Application for Works Approval

Works Approval Number	W6491/2021/1
Applicant	Eagle Bay Brewing Co. Pty Ltd
ACN	124 209 794
File number	DER2020/000672
Premises	Eagle Bay Brewing Co. 236 Eagle Bay Road NATURALISTE WA 6394 Legal description – Lots 150 and 151 on Plan 412213
Date of report	29 July 2021
Proposed Decision	Works approval granted

Figure 1: Proposed WWTP process diagram

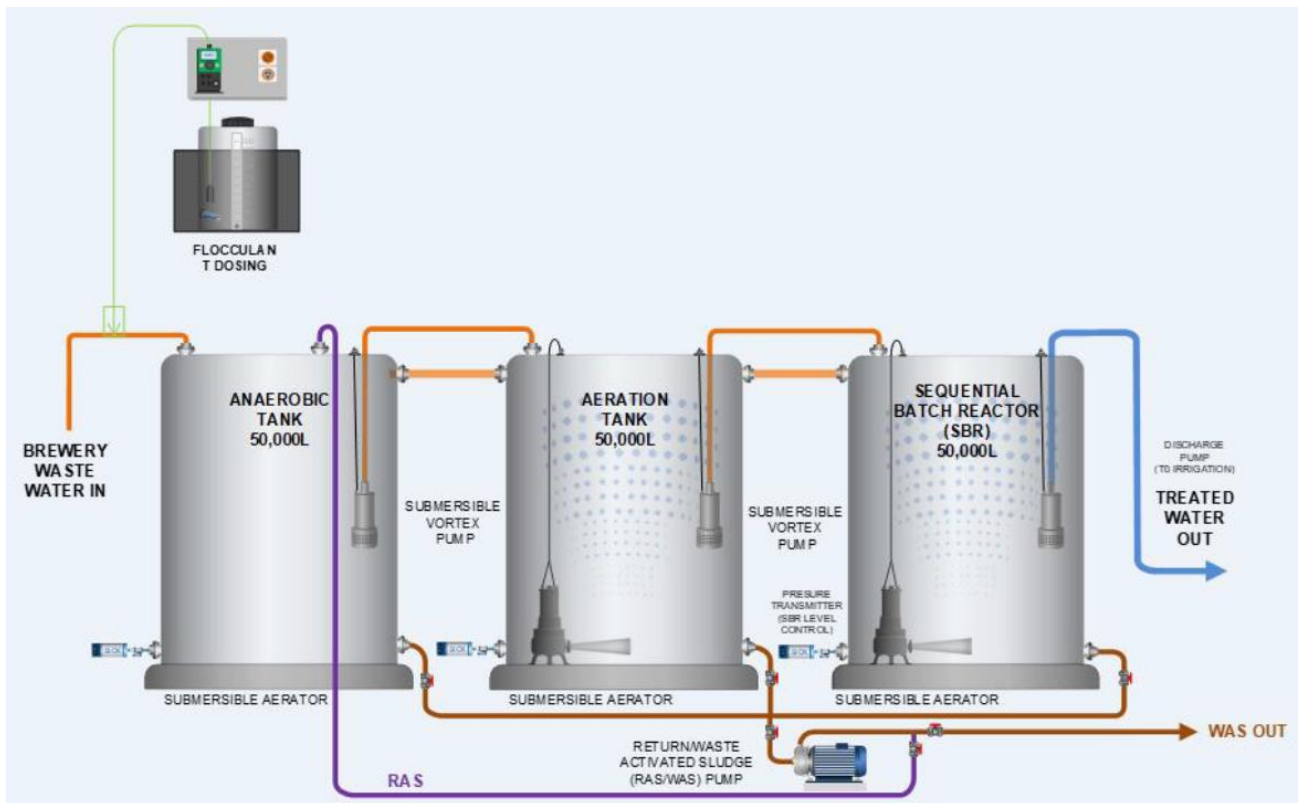
Summary of applicant's comment	Department's response
<p>Applicant provided/confirmed the following information:</p> <ul style="list-style-type: none"> • type of chemicals used as a flocculant – poly aluminium chloride; • size of the flocculant tank to be 200 L (approximately 930H by 580D); • sludge settled at the bottom of the tanks will be sent back to the anaerobic tank as an activated sludge; • a diagram showing the location of the sampling points: prior to flocculant dosing; and after treatment. 	<p>Relevant sections of the works approval and decision report have been updated.</p>
<p>Applicant has advised that the location of the wastewater treatment plant has moved slightly (approximately 30 m SW) from the original proposal. The applicant provided an updated map showing the new location.</p>	<p>Relevant map in the works approval has been updated. As the location has only moved a small amount (30 m) the distance to sensitive receptors (section 0) has not been updated.</p>
